DONCASTER BEVERLY DANBURY RECONSTRUCTION

CITY PROJECT NO. 14079
CONTRACT NO. 8709

ADDENDUM #1- 5/17/2024
REVISED THE FOLLOWING:
TITLE SHEET
SHEETS G12-G15
SHEETS PD1-PD2, PD5-PD6
SHEETS P1-P2, P5-P6
SHEET U2-U6
REMOVED THE FOLLOWING:
SHEETS G12 AND G16

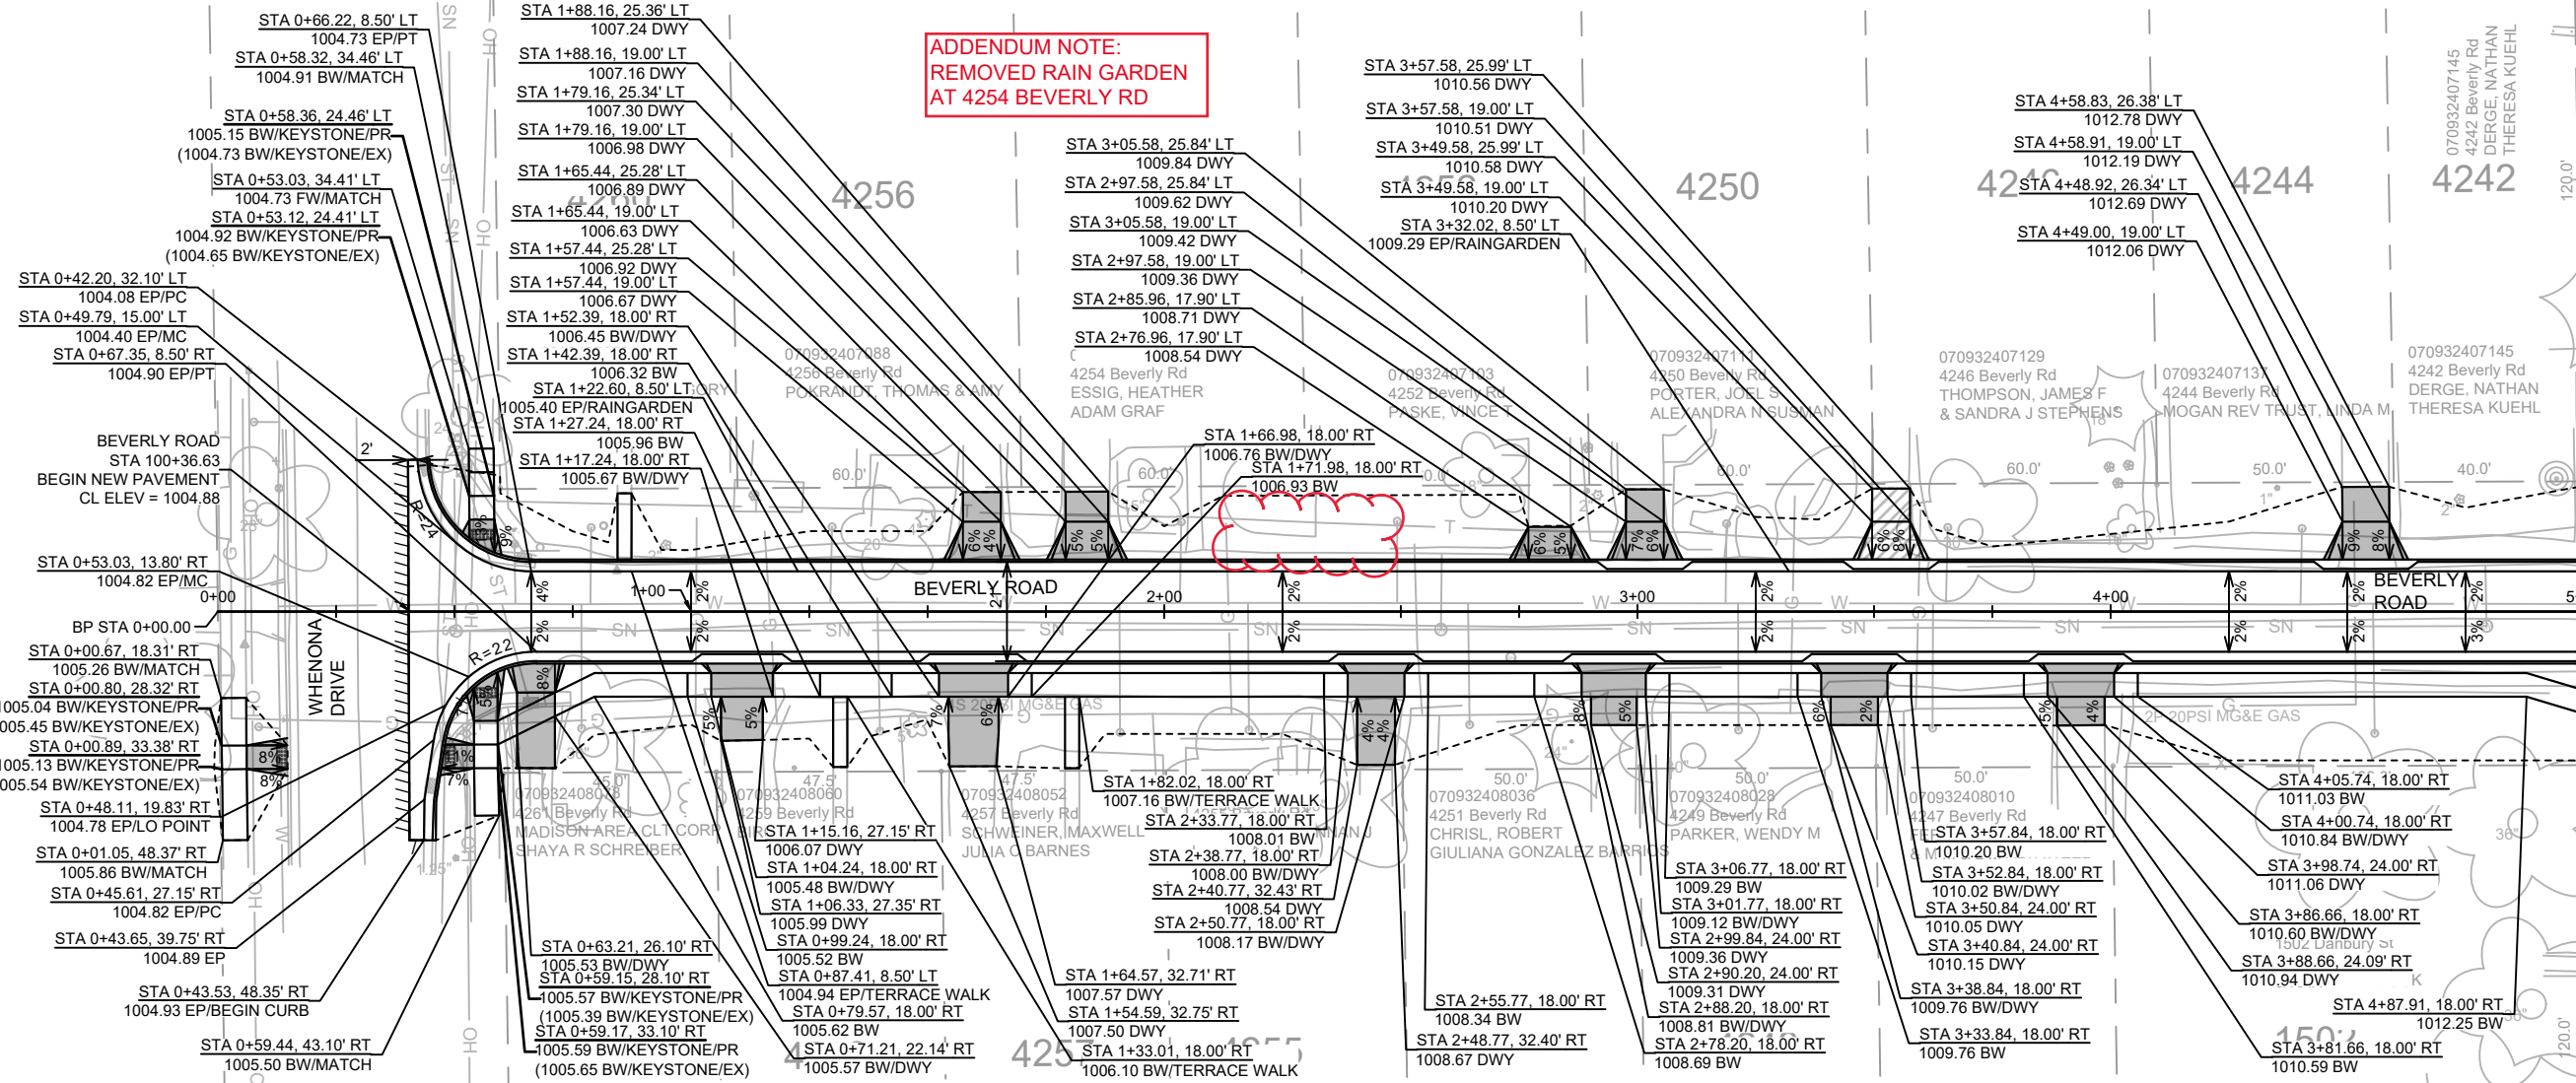
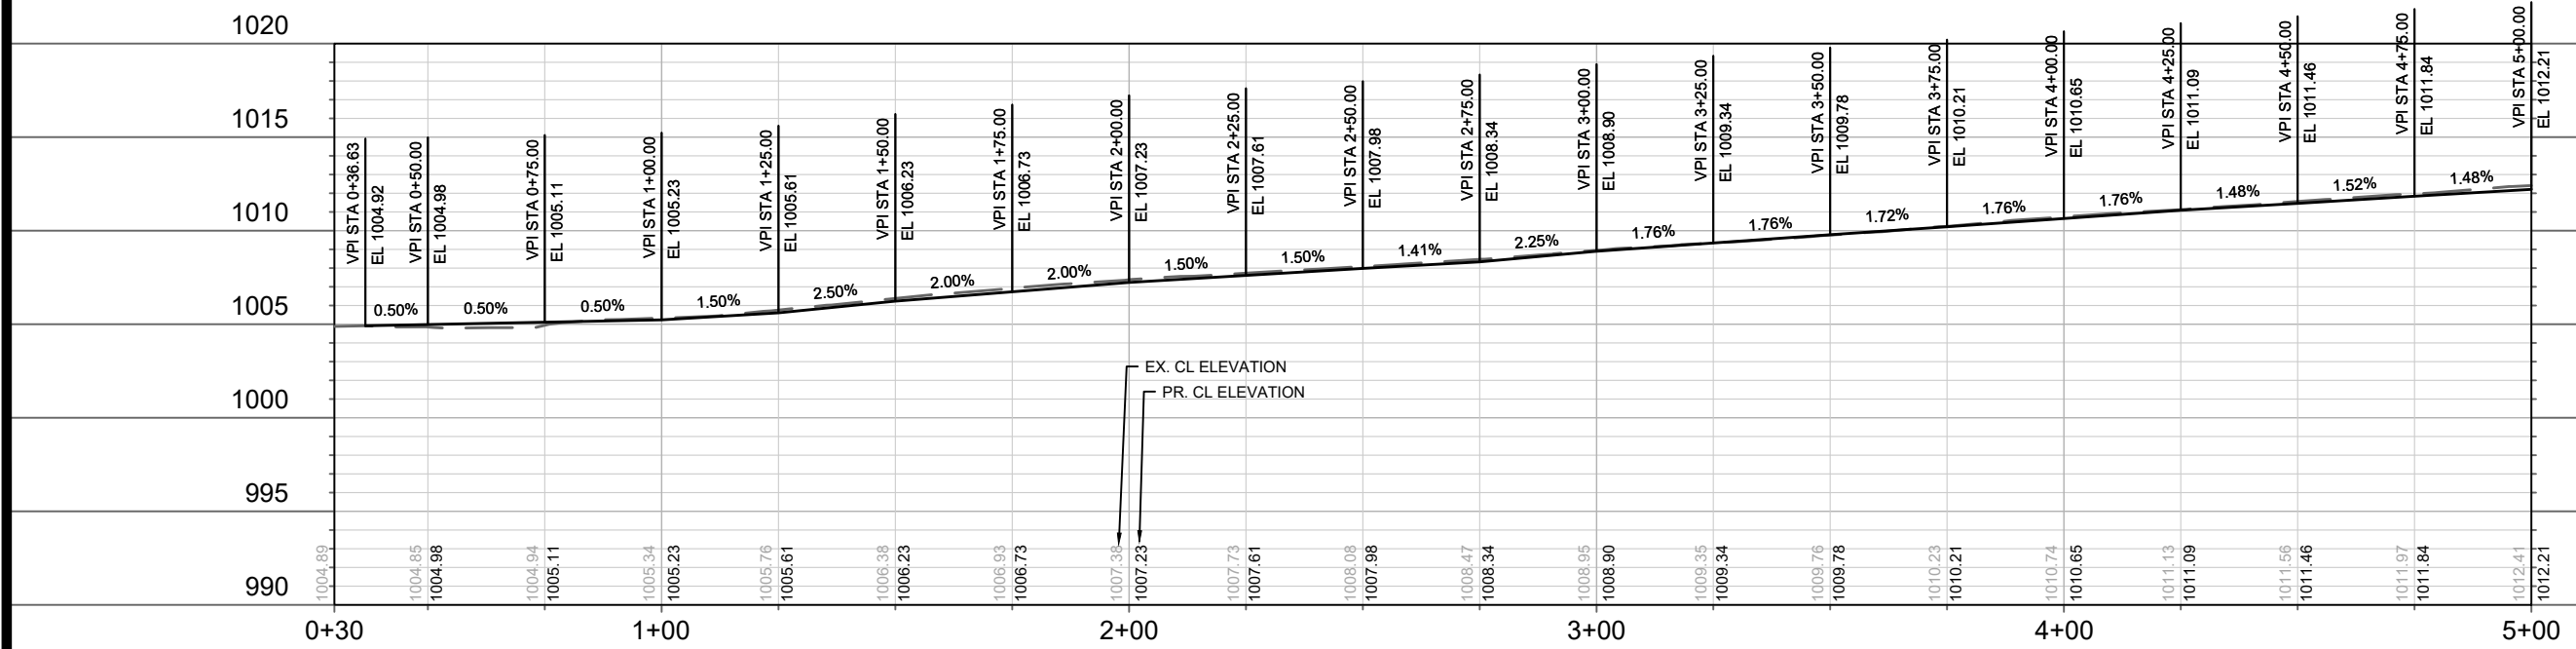
ADDENDUM NOTE:
REMOVED RAIN GARDEN
AT 4254 BEVERLY RD

14079	MADISON, WI	8709	CONTRACT NO.
BEVERLY ROAD PLAN & PROFILE			
DONCASTER BEVERLY DANBURY RECONSTRUCTION			
M:\DESIGN\Projects\14079\CAD\Streets\14079EN-PnP.dwg			
14079	P-2

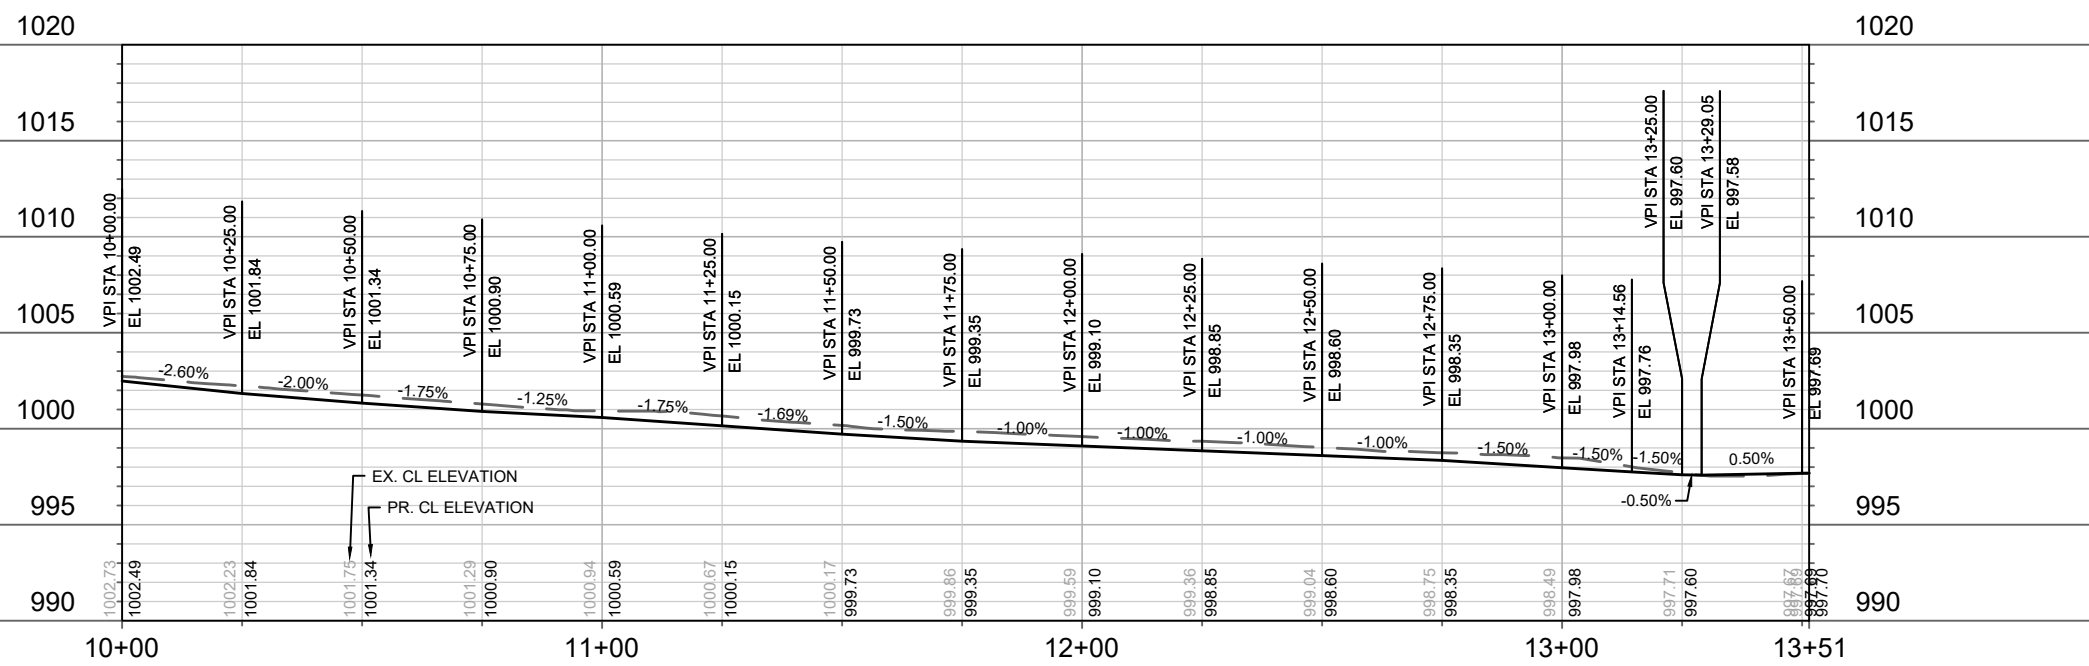
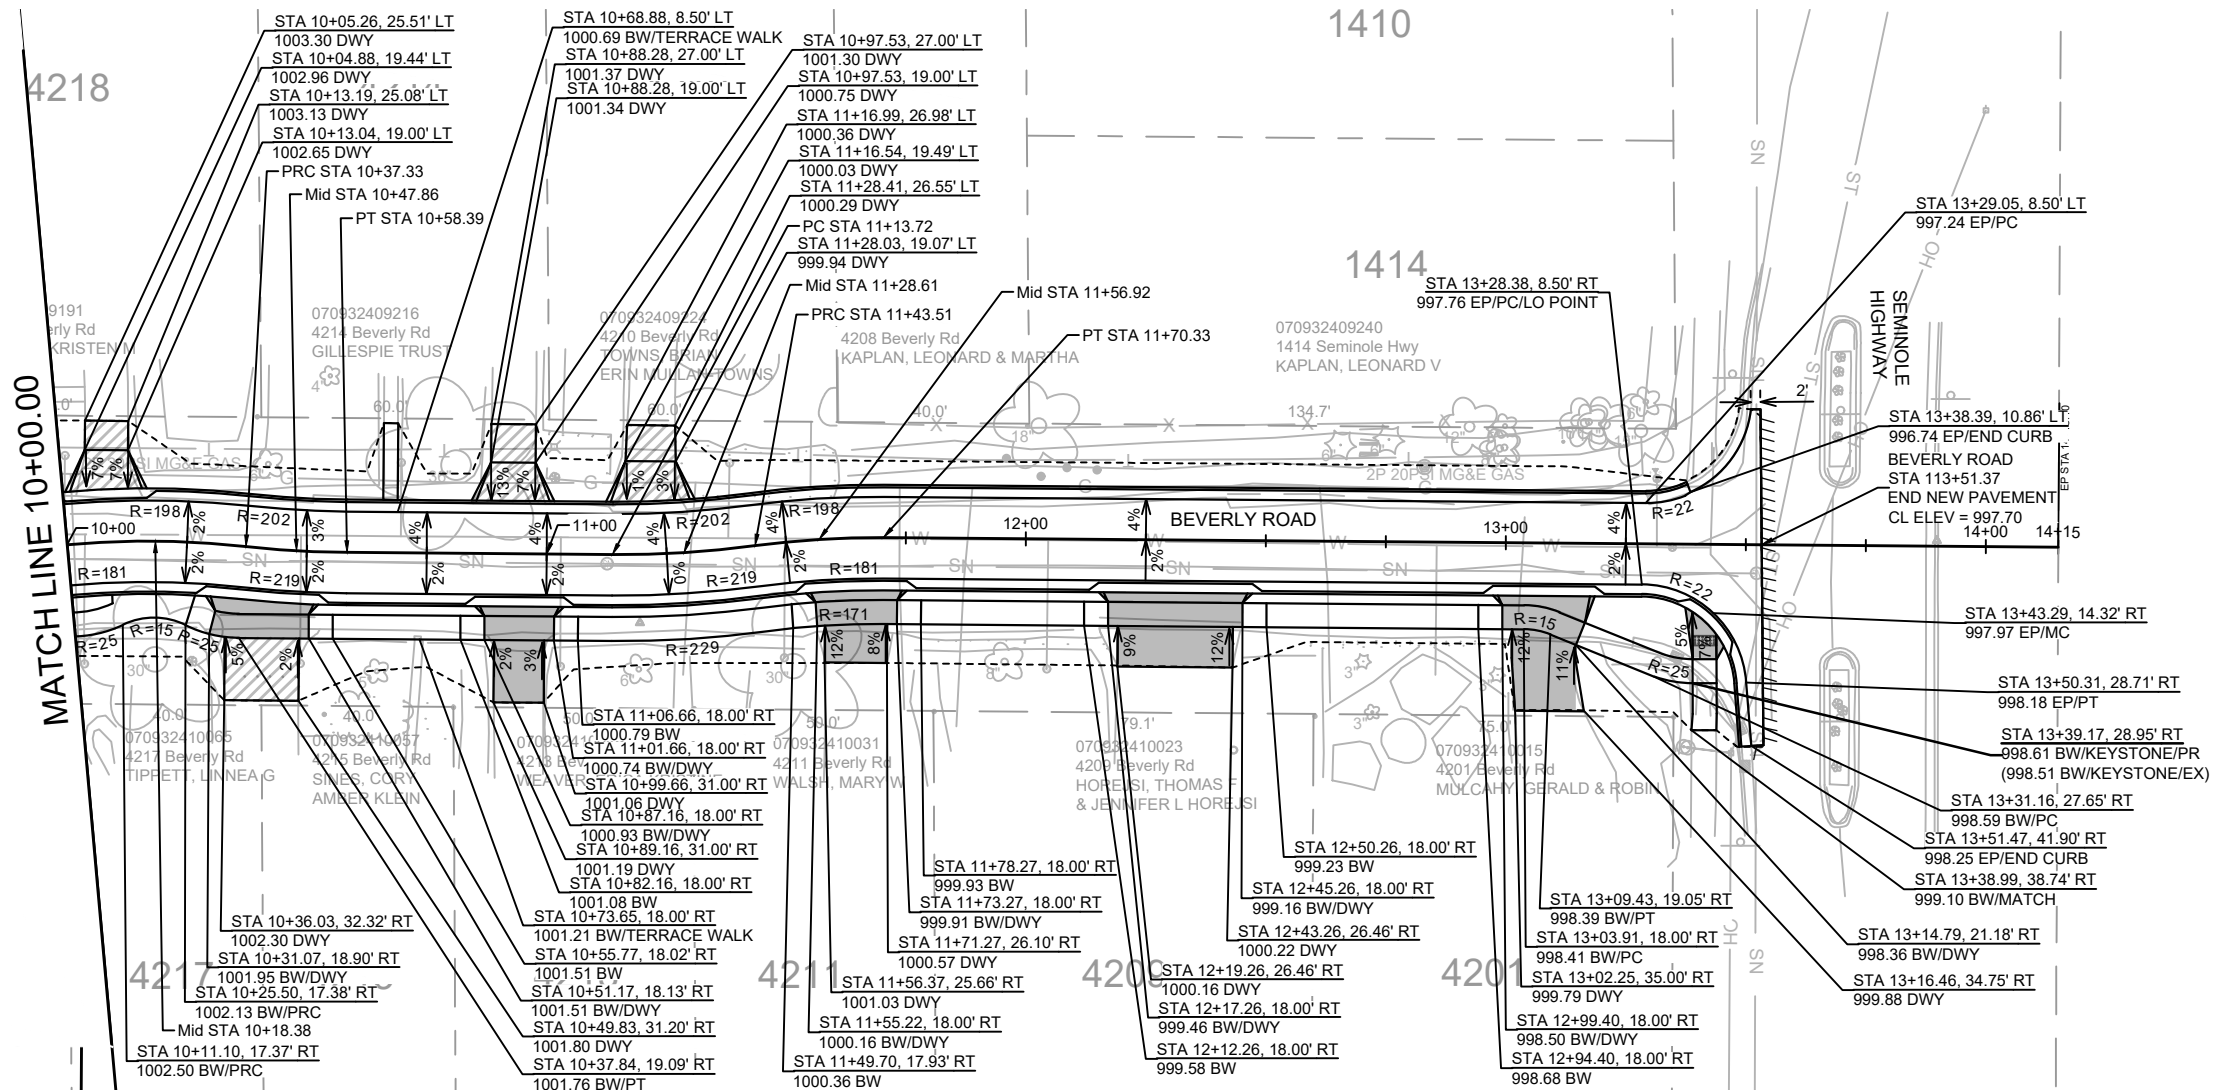
ADDENDUM NOTE:
REMOVED TERRACE
WALK AT 1502 DANBURY
ST
